TIGERTOWN

SUITE RENOVATIONS

DESCRIPTION: 10.09.17 ISSUED SET 10.26.17 REV 1 - REVISED FOR CLARIFICATION

NEW FLOOR PLAN

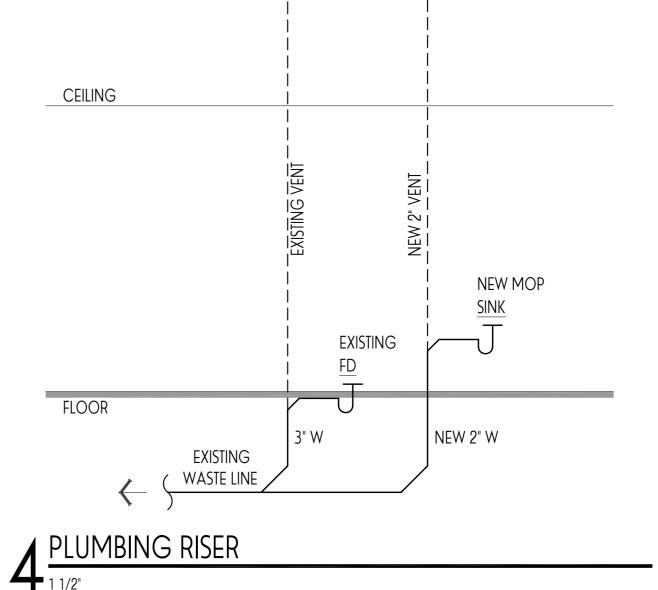
ADDED MOP SINK AND FILLER FAUCET AS SELECTED BY OWNER. ROUTE NEW HOT AND COLD WATER SUPPLY FROM ATTIC TO LOCATION IN WALL. ROUTE NEW 2" SANITARY DRAIN LINE FROM FLOOR SINK IN ADJACENT RESTROOM (SAWCUT, DEMO AND PLACE CONCRETE SLAB AS REQUIRED). PROVIDE NEW HUB DRAIN AND 2" VENT (TIE INTO EXISTING VENT LINE IN ATTC). COORDINATE FINAL LOCATION OF NEW SINK AND PLUMBING ON JOBSITE.

REV 2 - REVISED DPW REVIEW

REV 3 - REVISED PER OWNER
